BID ADDENDUM #6

**Nanuet Union Free School District
103 Church Street
Nanuet, NY 10954**

Nanuet Bond Projects Phase 3

Date: July 12, 2023

HS-M104

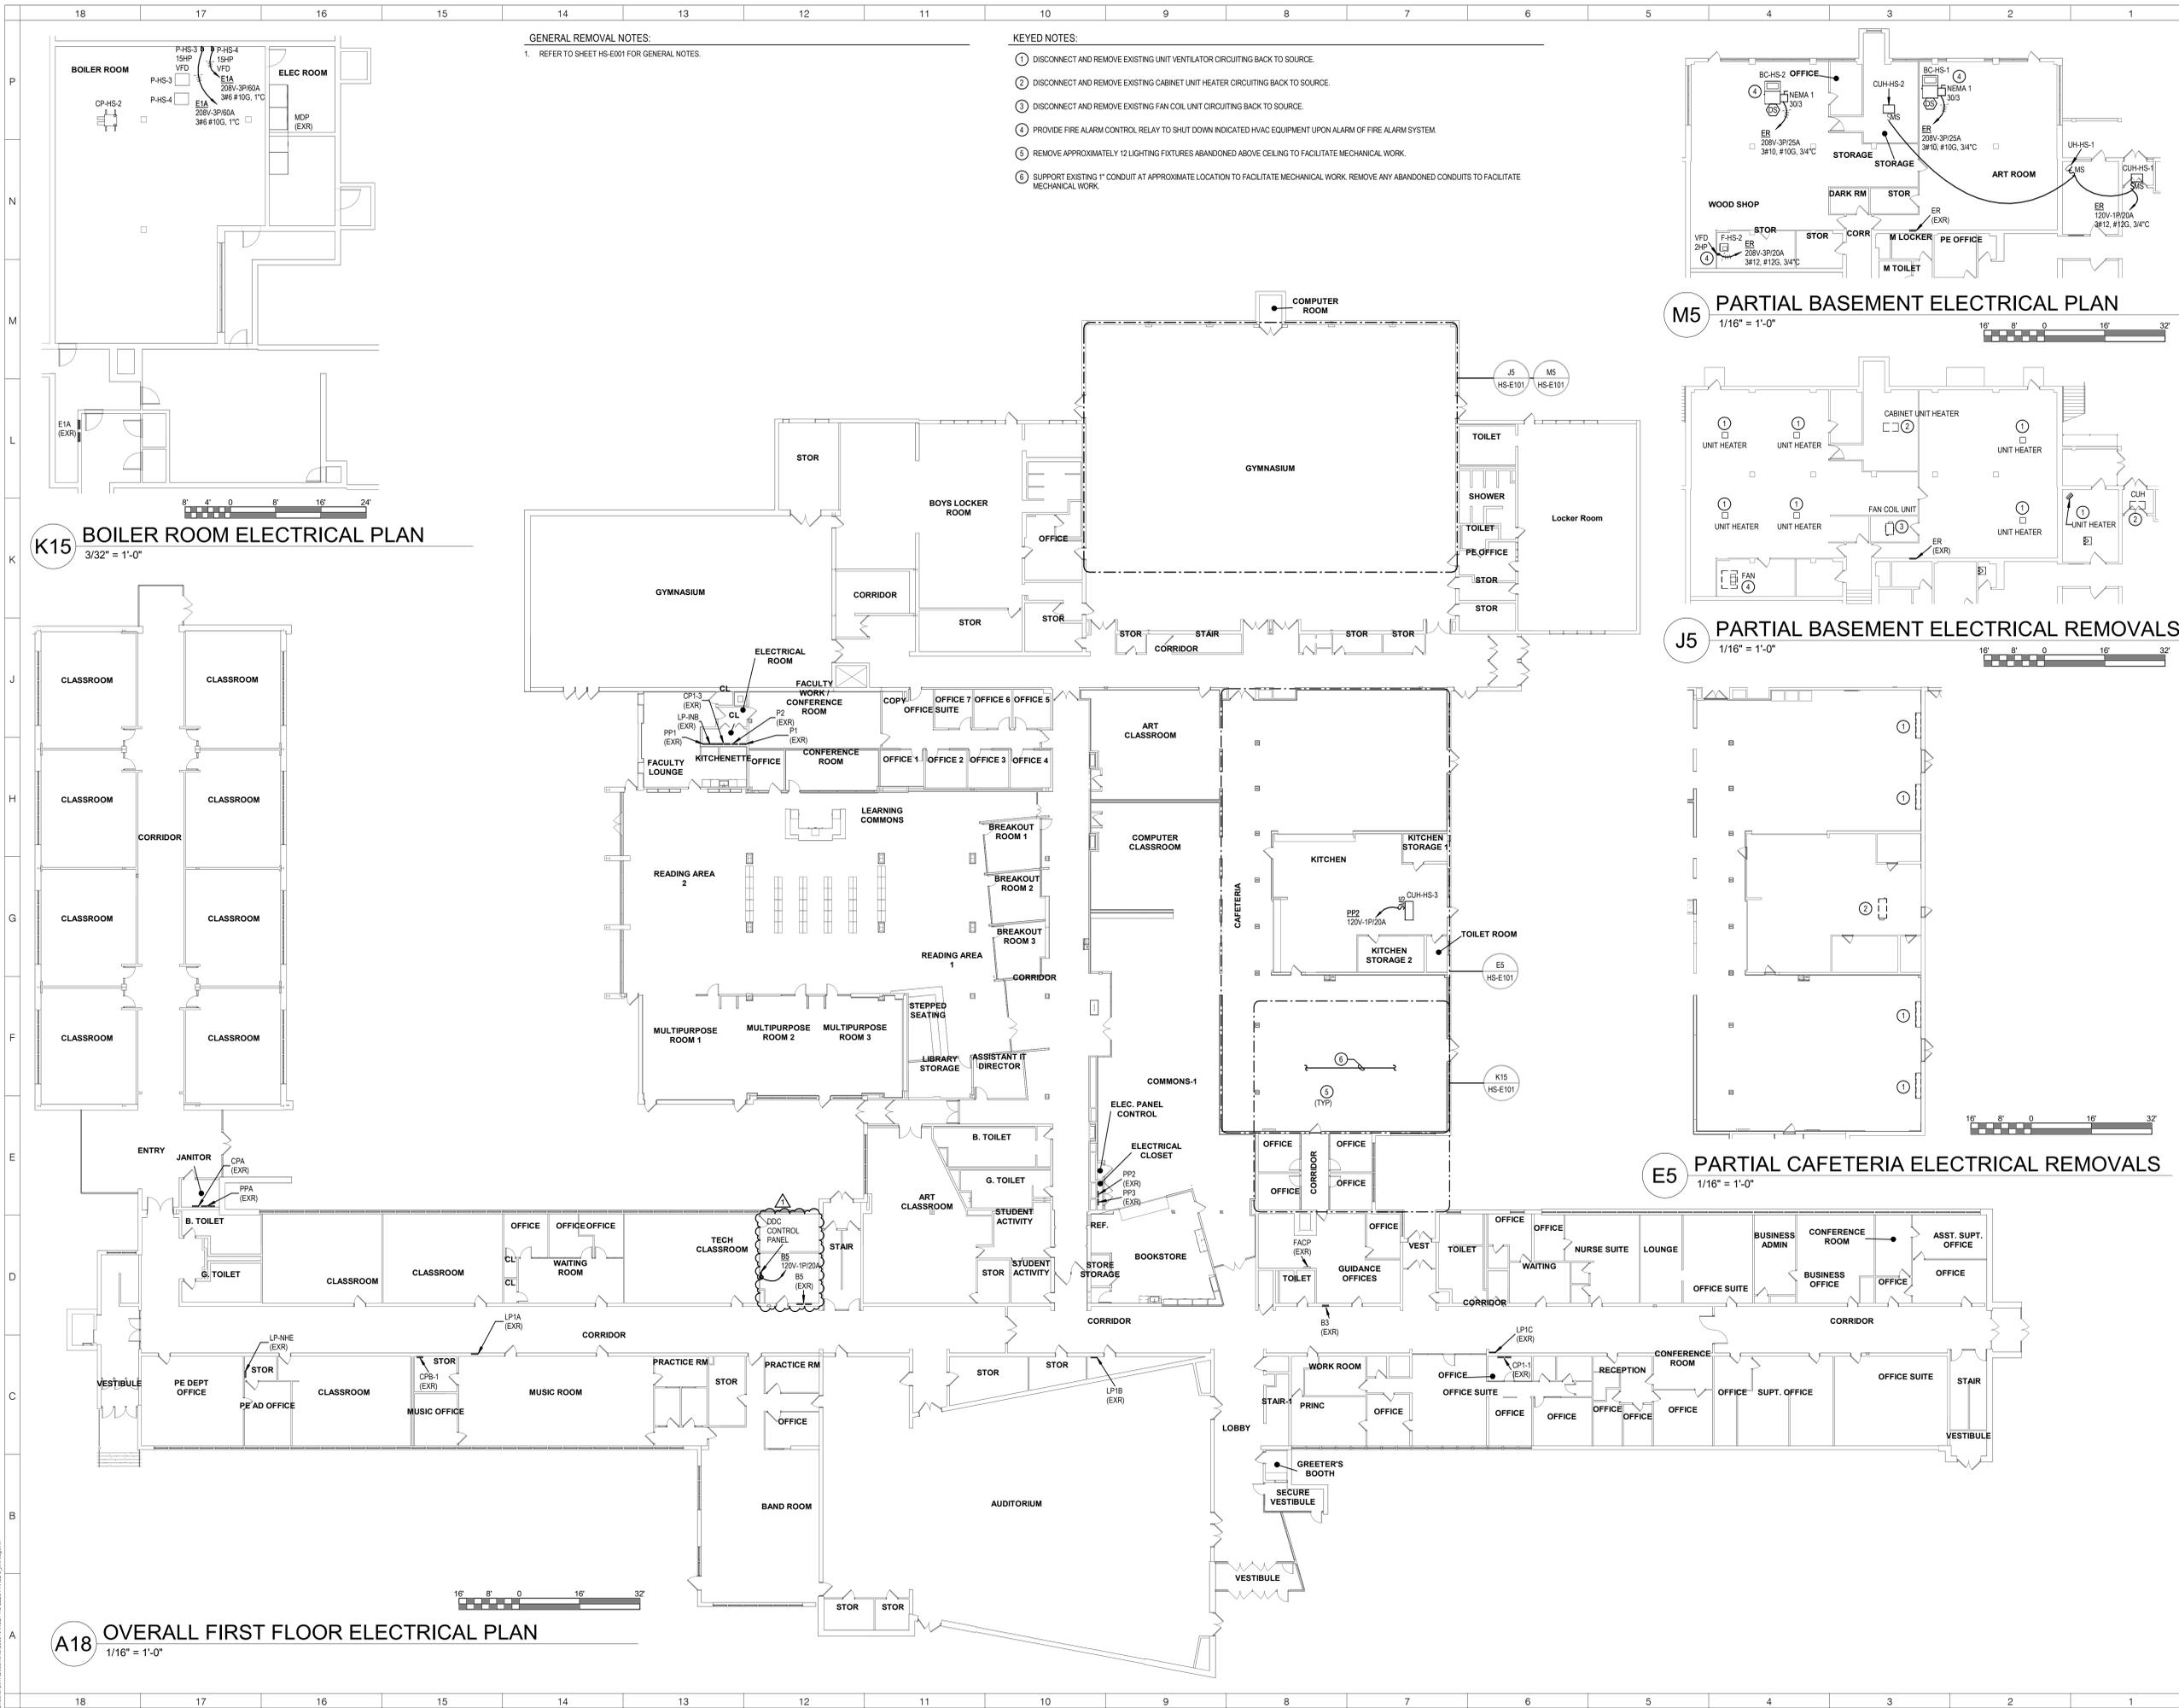
- a. Regarding Pneumatic control demo: would it be acceptable to cap open/obsolete pneumatic tubing, remove obsolete pneumatic tubing where exposed to view, and abandon in-place pneumatic tubing that is concealed or in otherwise inaccessible areas or above access from a 10 ft ladder height?

Response: Refer to revised Mechanical drawings BM M104-M108 and HS M103-105 that clarify the pneumatic tubing removal requirements
 - b. Regarding electronic control wiring demo: would it be acceptable electrically isolate the wiring on both ends and leave the wiring abandoned in-place when bundled with other active wiring or routed in concealed or in otherwise inaccessible areas or above access from a 10 ft ladder height?

- REGARDING PNEUMATIC CONTROL SYSTEM REMOVAL WORK: CAP OPEN/OBSOLETE PNEUMATIC TUBING AT ALL LOCATIONS. REMOVE OBSOLETE/DISCONNECTED PNEUMATIC TUBING WHERE EXPOSED TO VIEW. ABANDON IN-PLACE PNEUMATIC TUBING THAT IS CONCEALED OR IN OTHERWISE INACCESSIBLE AREAS.
